Operator: CIVITAS NORTH
Location Name: Rothe 12-14-8-61
Loc ID: 424216
Inspection: 709100217

Exhibit A

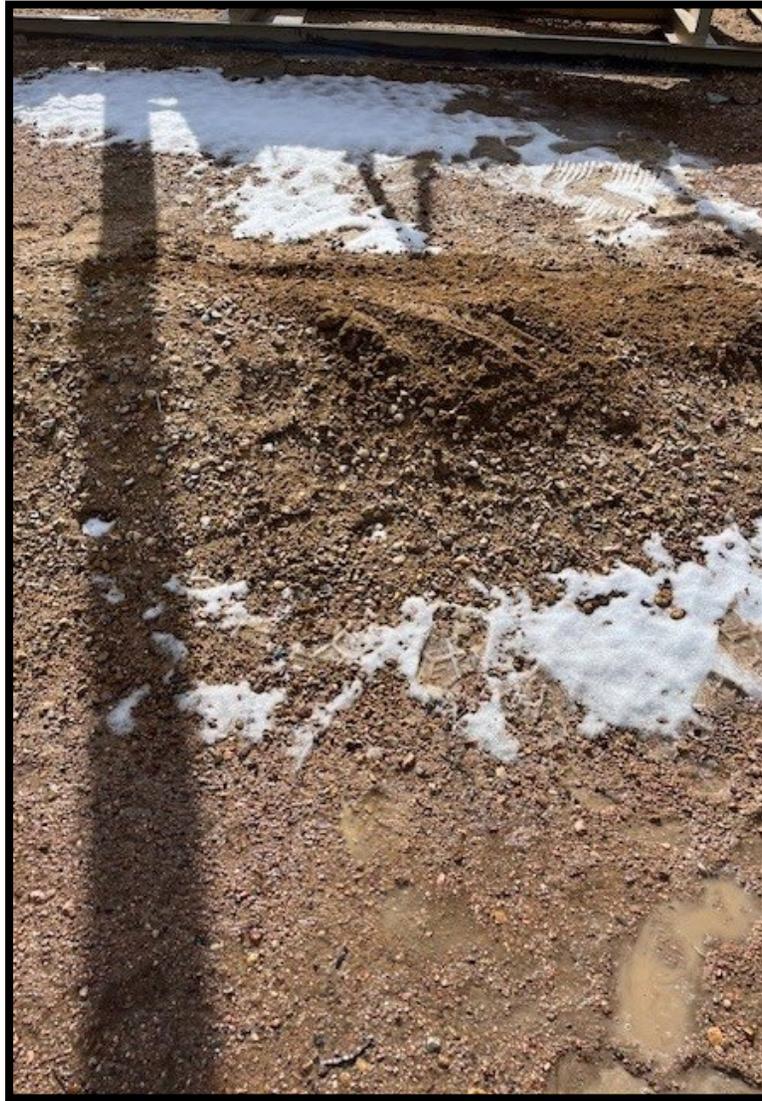
CA: No signage observed at wellhead. Comply with Rule 605.a. and Rule 605.d.

CA Resolution: Operator has appropriately updated Well signage to comply with Rule 605.a and 605.d.

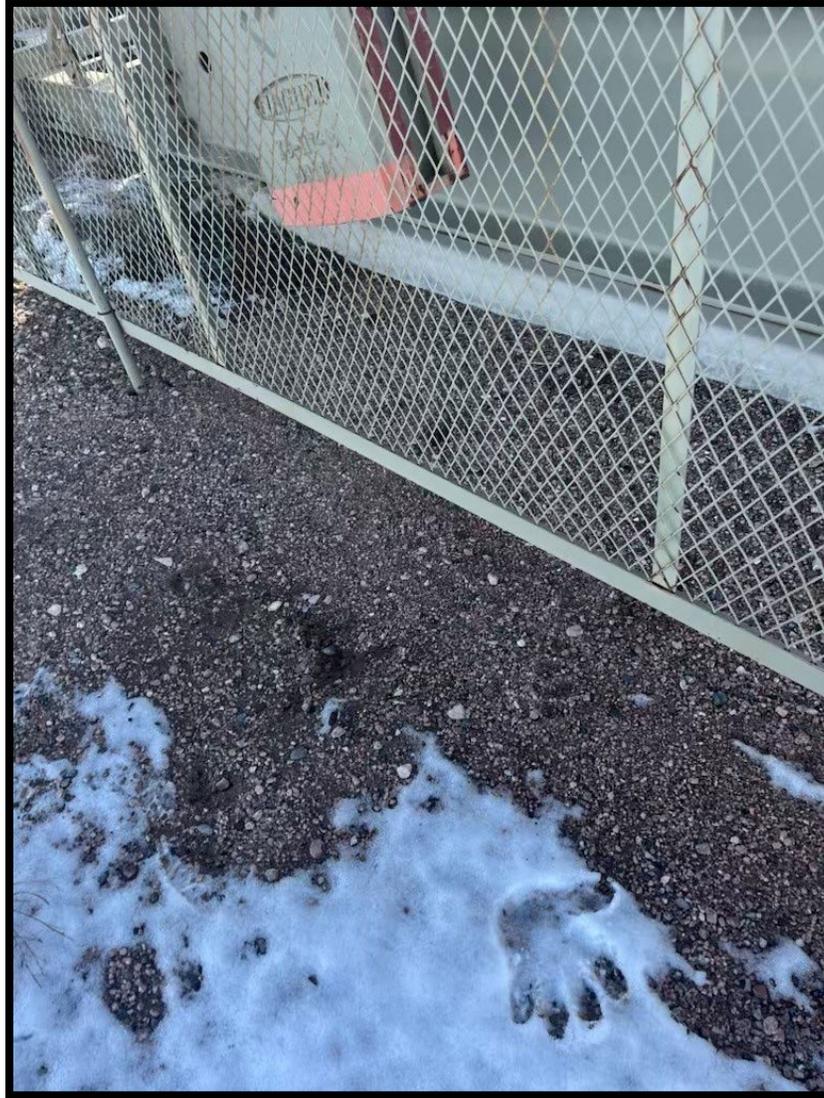
CA: Trash (plastic, metal, buckets, wood block, hosing, cloth) located on site. Comply with Rule 606

CA: Weeds located among Pump Jack and within secondary containment. Comply with Rule 606

CA: Hydrocarbon-stained soils observed next to metal shed and within metal shed. Control and contain spills/releases and clean up per Rule 912.a.

CA: Berms around horizontal heater treater are insufficient. Burrows observed on location. Repair or install berms or other secondary containment devices per Rule 608.

CA Resolution: Operator has removed all identified trash, debris, and unused equipment from the location to comply with Rule 606.

CA Resolution: Operator has cleared the identified weeds and weed debris to comply with Rule 606.

CA Resolution: Operator has appropriately cleaned and disposed of identified stained soil to comply with Rule 912.a.

CA Resolution: Operator addressed the issue to comply with Rule 608.
